Duquesne Light Company
(Beaver Valley Power Station, Unit No. 1)

APPLICATION FOR AMENDMENT
INSERVICE INSPECTION REQUIREMENTS

Requests for Relief from Hydrostatic
Inservice Inspection Requirements

Attachment A.1

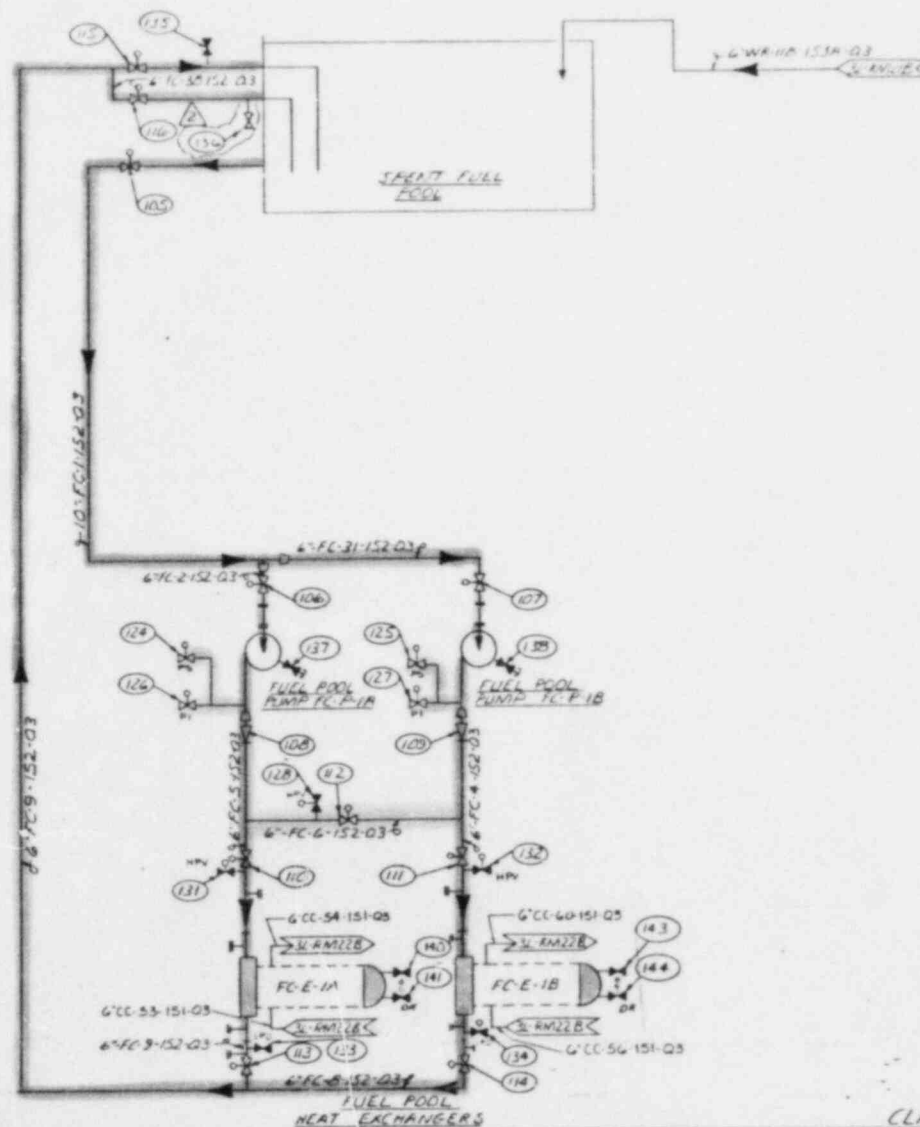
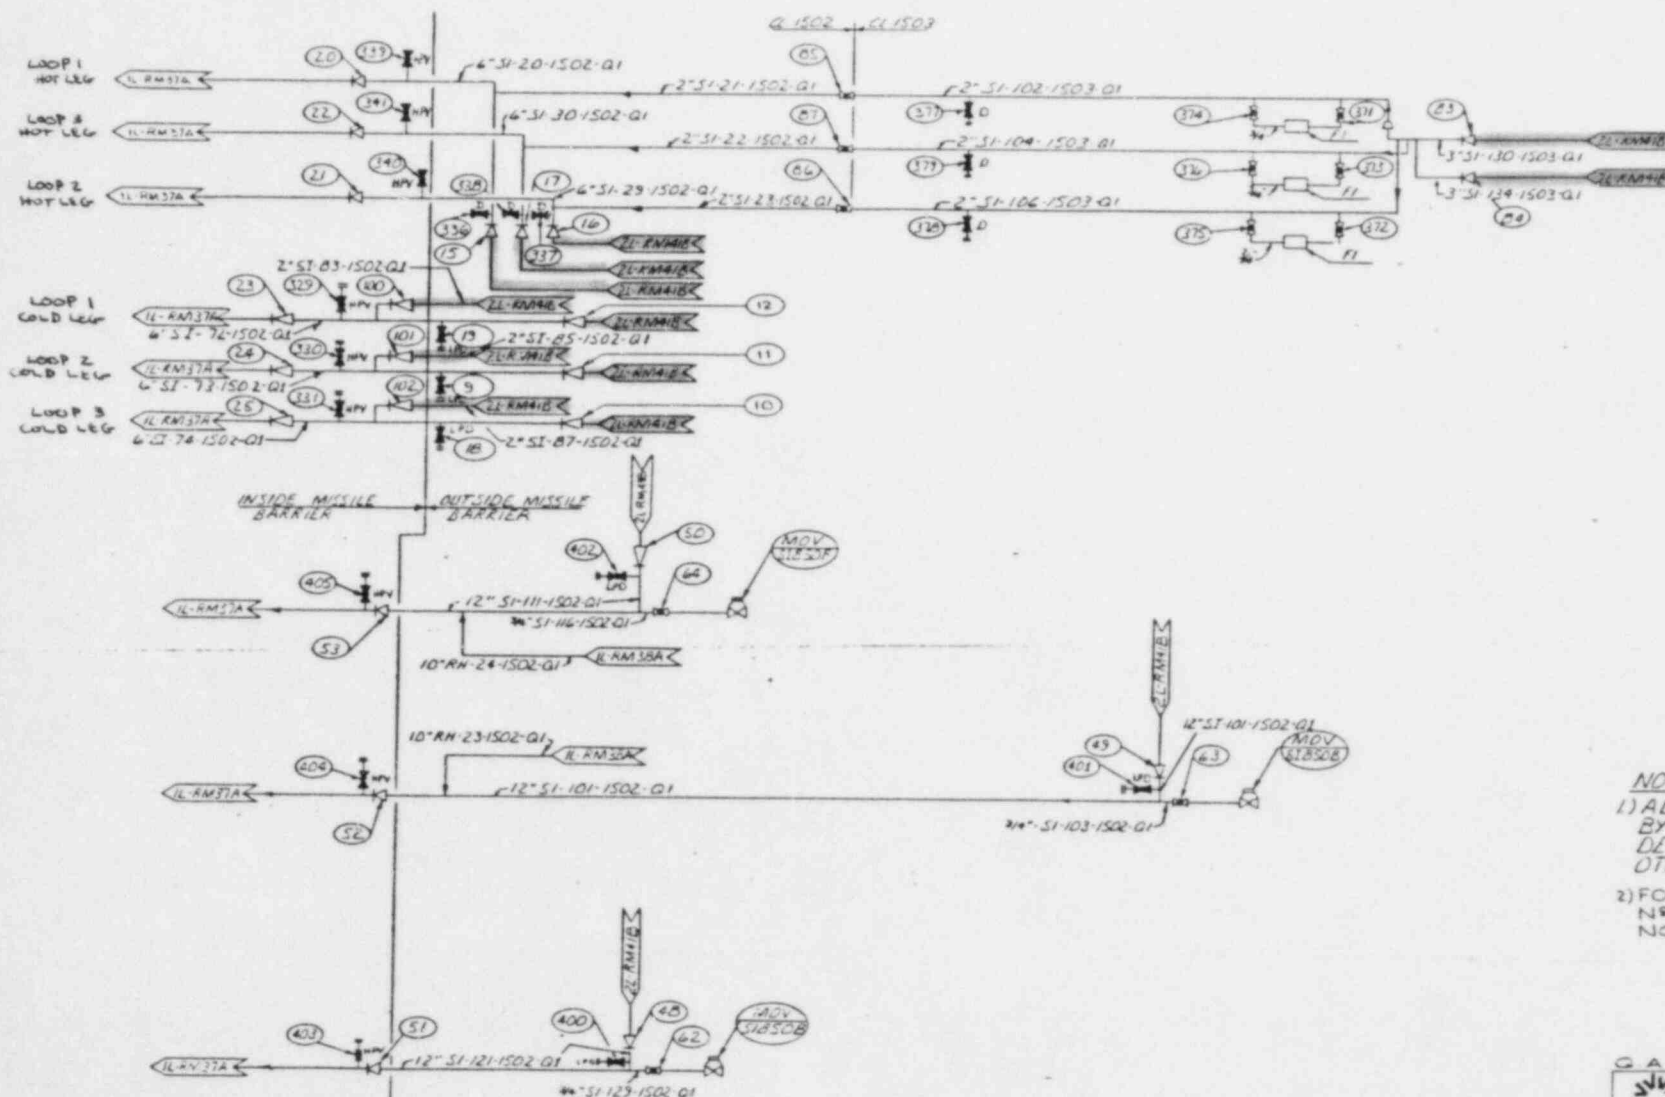
Class 3 systems that are in continuous use; specifically, portions of the River Water and Fuel Pool Cooling Systems and the entire Reactor Plant Component Cooling Water System. (See Attachment A.1 drawings.)

Hydrostatic testing on portions of these systems is impractical since they are required to be in continuous operation during all modes of plant operation. The continuous functional operation serves to demonstrate structural and leak-tight integrity of these systems. Visual examinations of these systems at normal operating pressures will provide adequate confidence of the leak-tightness of the systems.

Visual examination of the affected components will be performed at normal operating pressures.

Attachment C.1

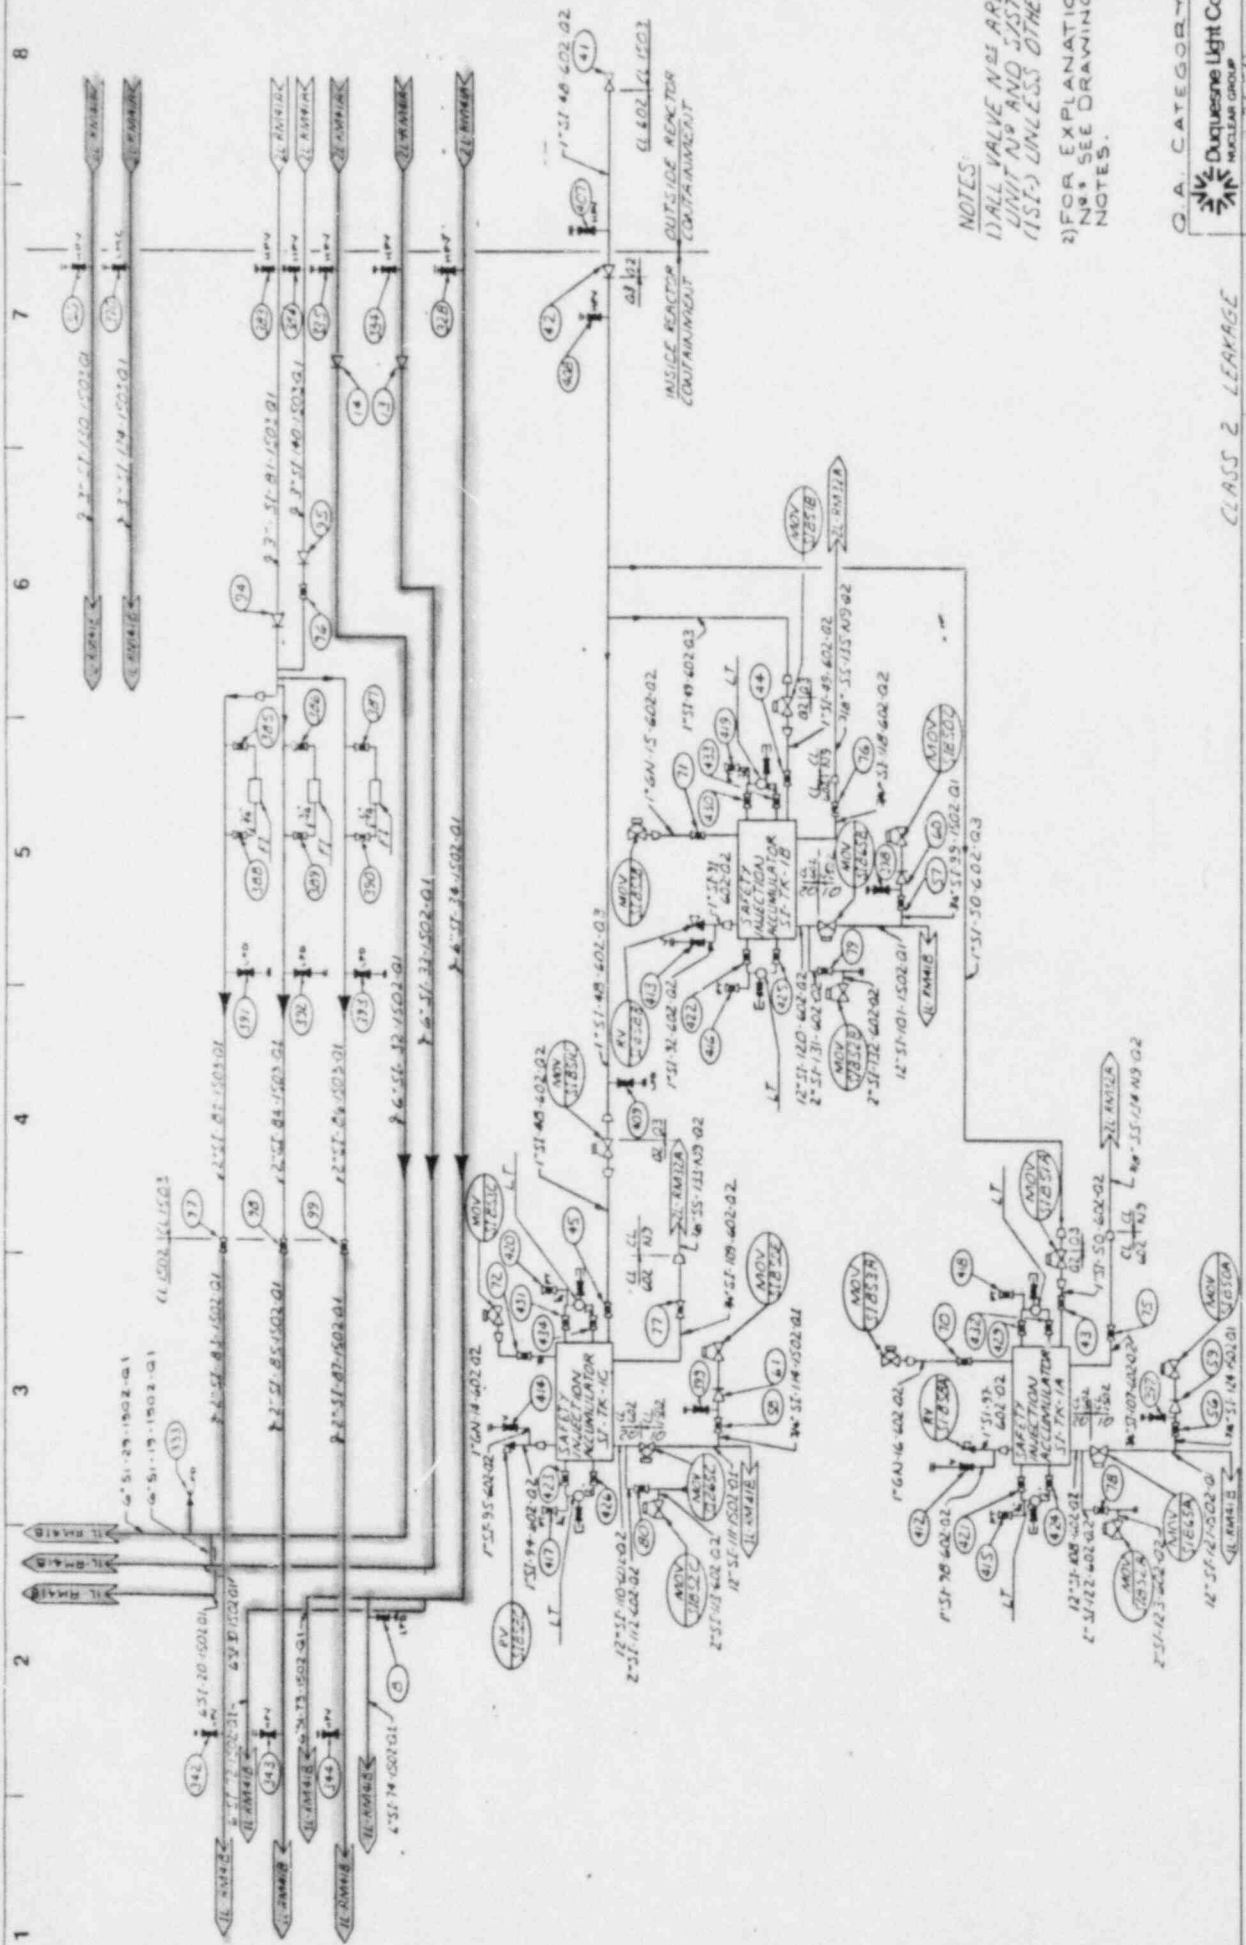
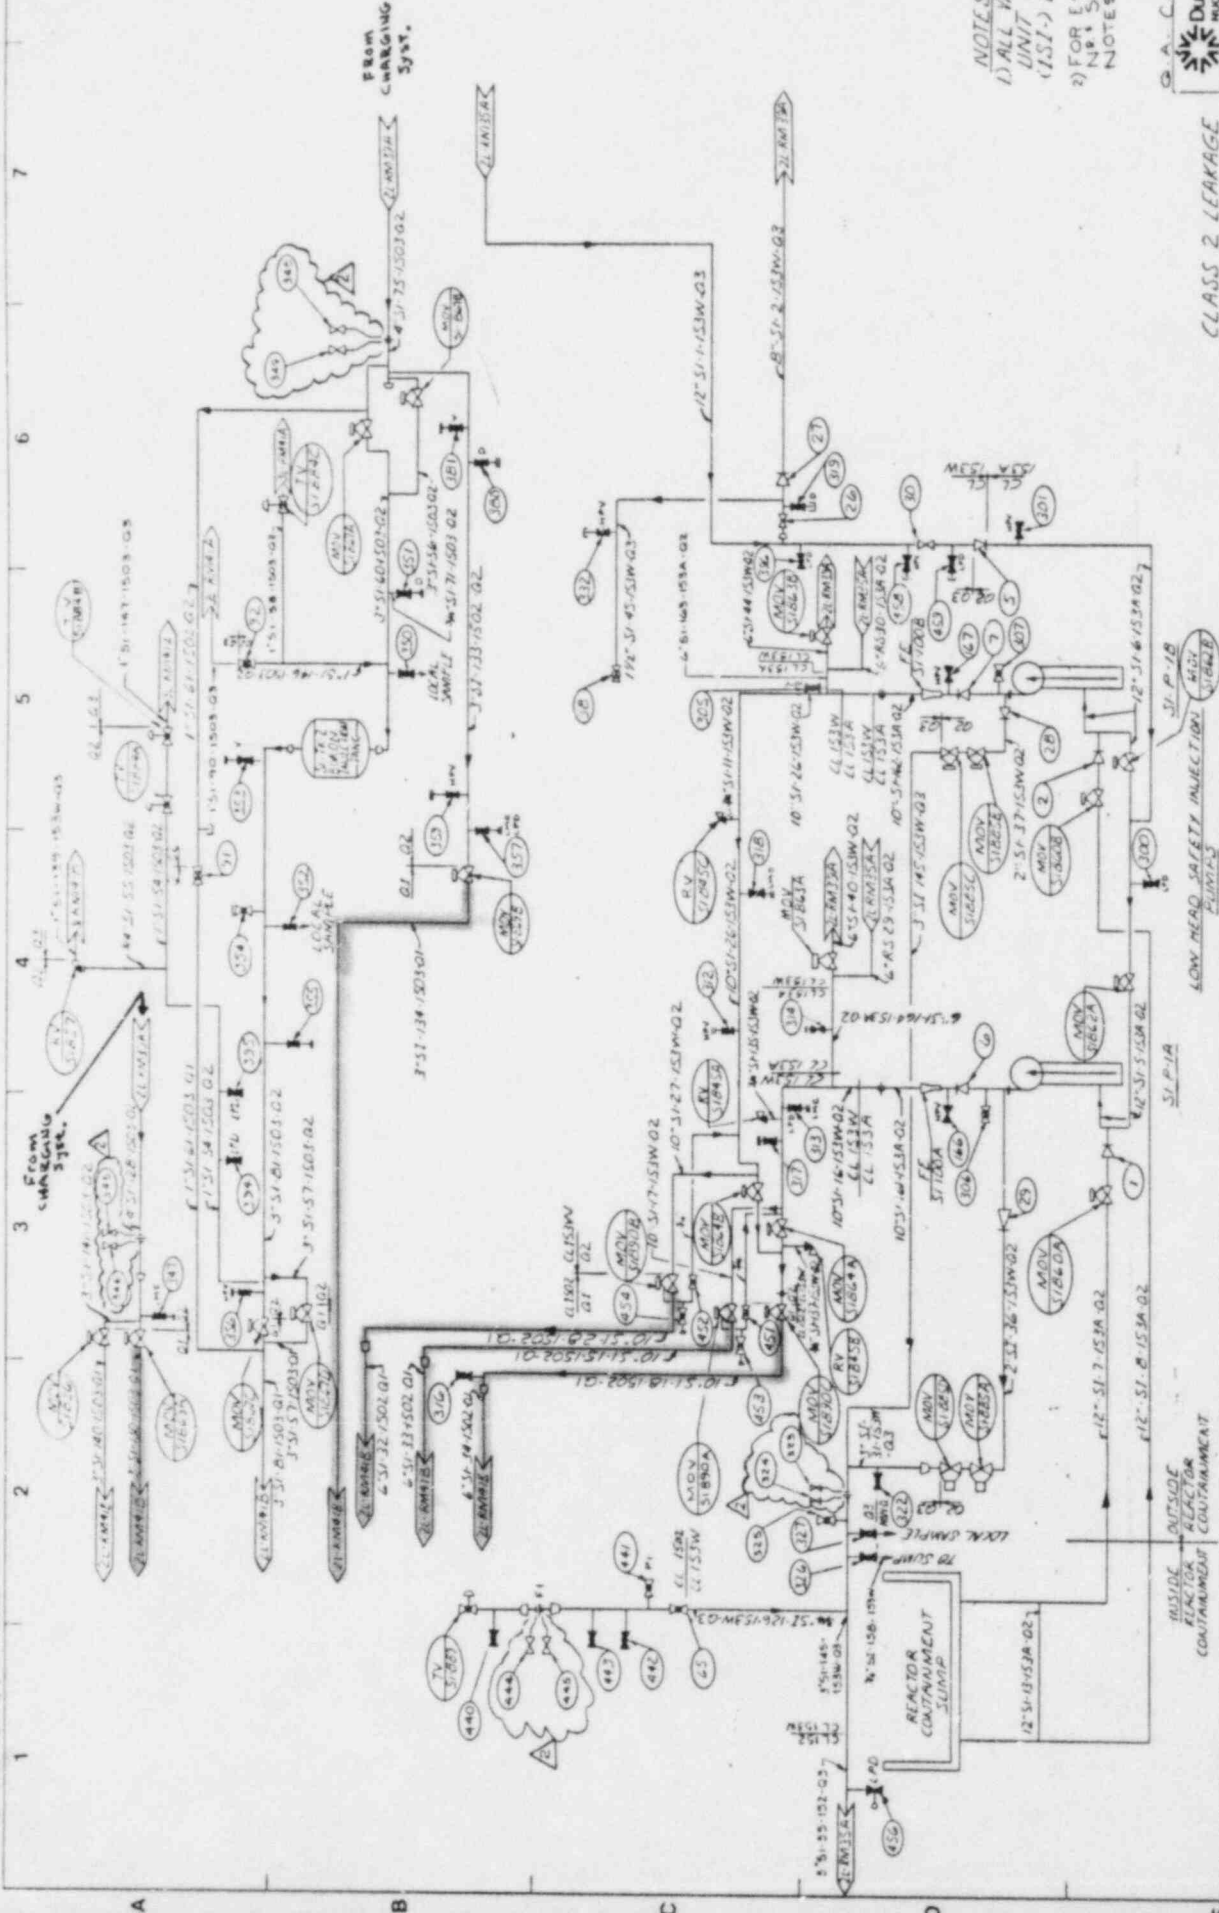
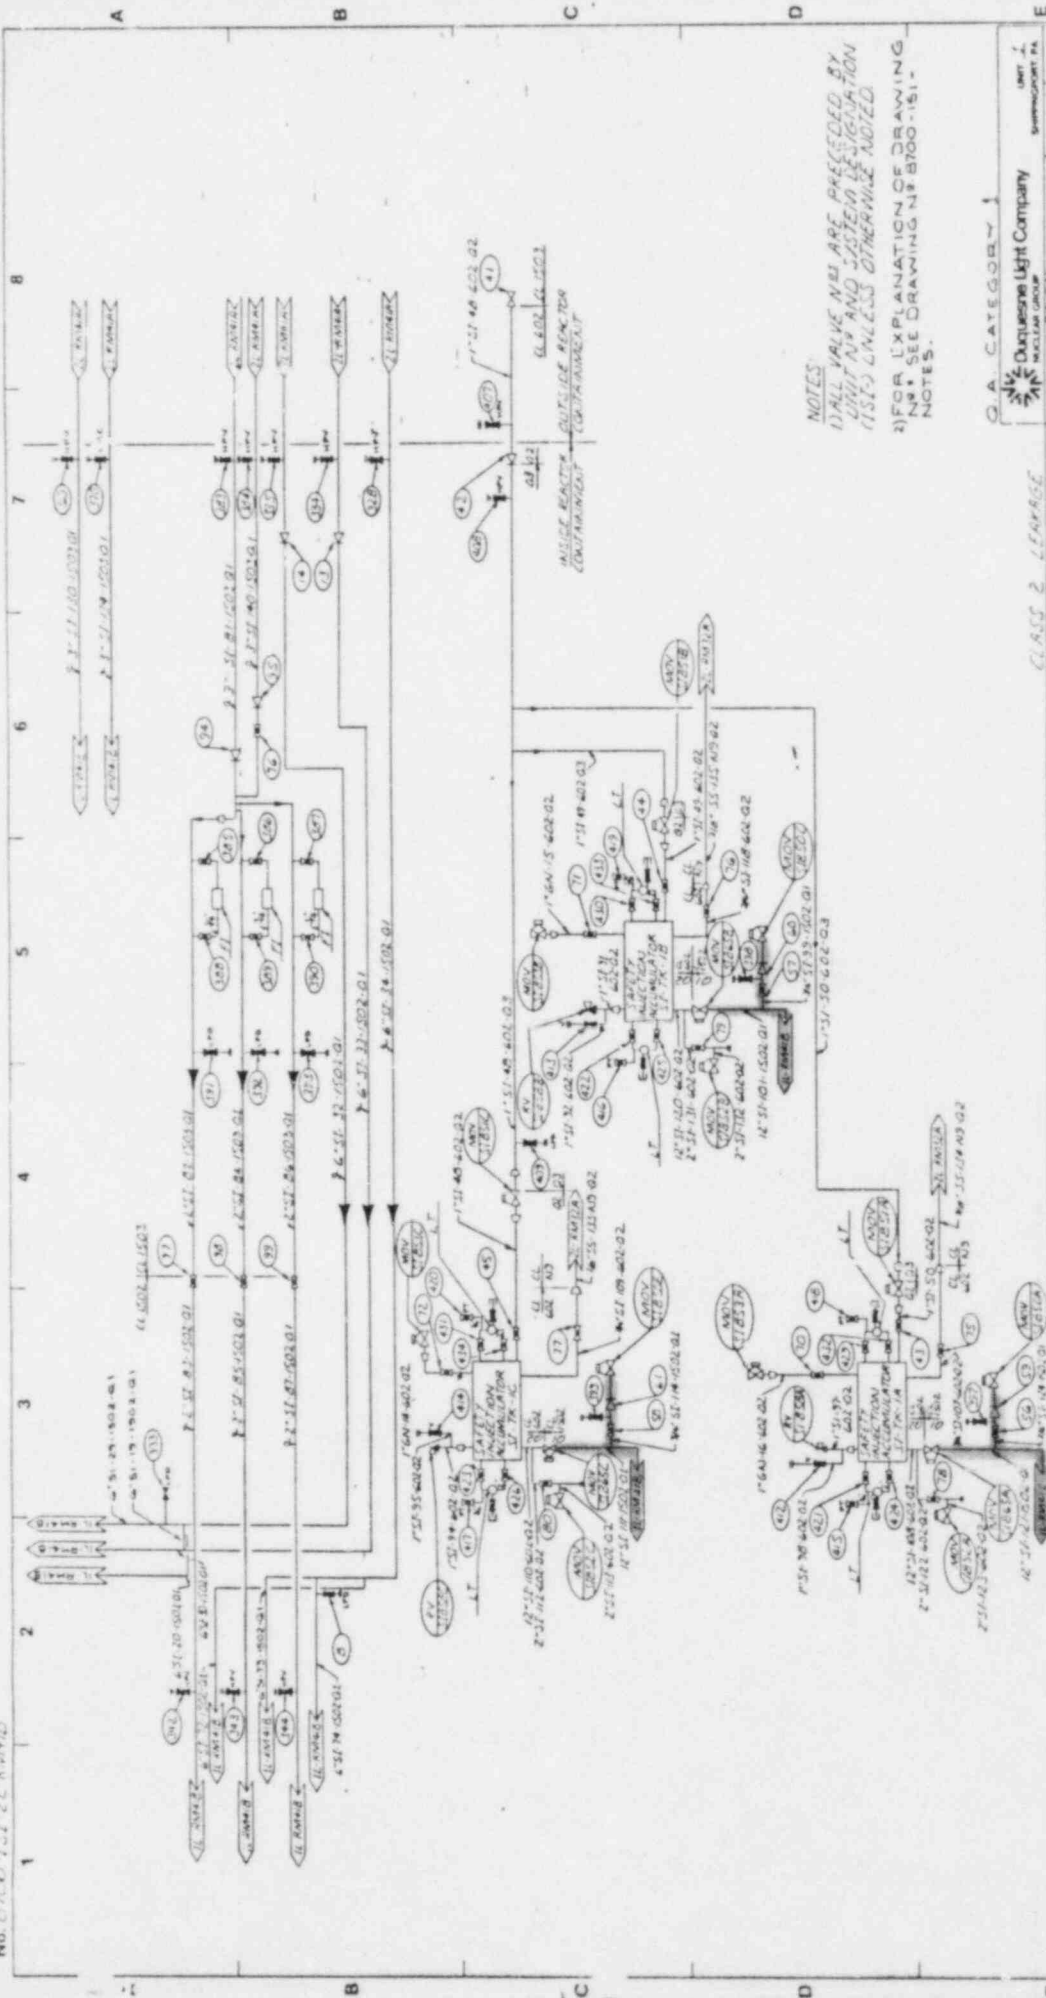
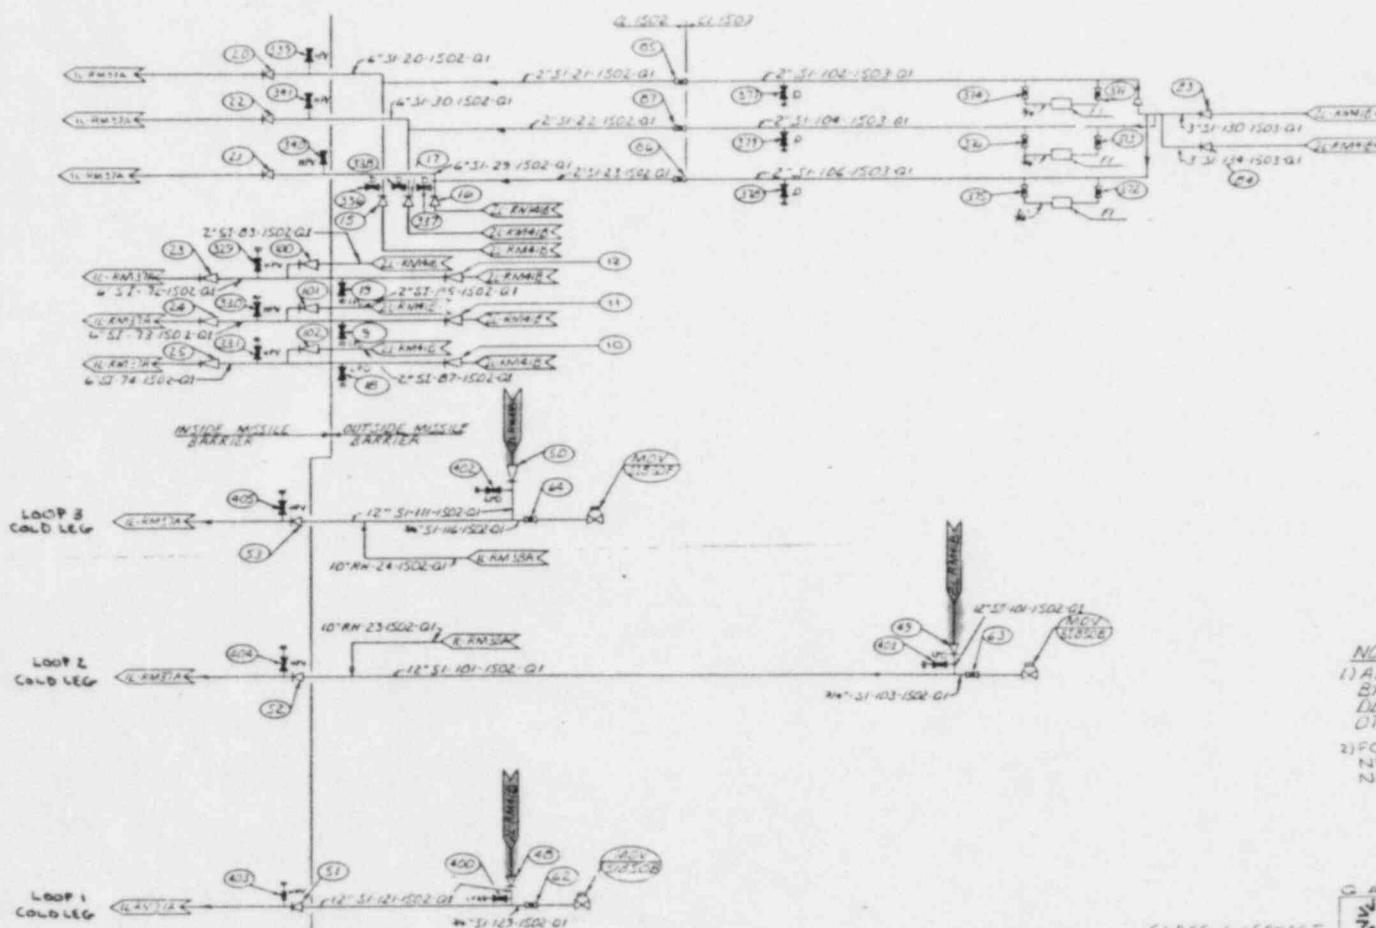
The following sections of Class 2 piping are affected (see Attachment C.1 drawings):

- (a) Cold leg injection lines between valves SI-97 and SI-100, SI-98 and SI-101, and SI-99 and SI-102.
- (b) Cold leg injection lines between valve MOV-SI-890C and valves SI-10, SI-11, and SI-12.
- (c) Hot leg injection lines between valve MOV-SI-890A and valves SI-15, SI-16, and SI-17 and between valve MOV-SI-890B and valves SI-15, SI-16, and SI-17.
- (d) Hot leg injection lines between valve MOV-SI-869A and valve SI-83 and between valve MOV-SI-869B and valve SI-84.
- (e) Safety Injection Accumulator lines:
 - 1. From valve MOV-SI-865A to valves MOV-SI-850A and SI-48.
 - 2. From valve MOV-SI-865B to valves MOV-SI-850C and SI-49.
 - 3. From valve MOV-SI-865C to valves MOV-SI-850E and SI-50.

The lines noted above cannot be isolated from the reactor coolant system if the Class 2 hydrostatic test pressure is applied. Hydrostatic testing of these lines to the Class 2 test pressure would overpressurize the reactor coolant system.

These portions of Class 2 piping will be hydrostatic tested at the reactor coolant system test pressure (1.02 Po). Vent and drain valves will be utilized as jumpers past check valves to allow pressurization of the Class 2 piping.
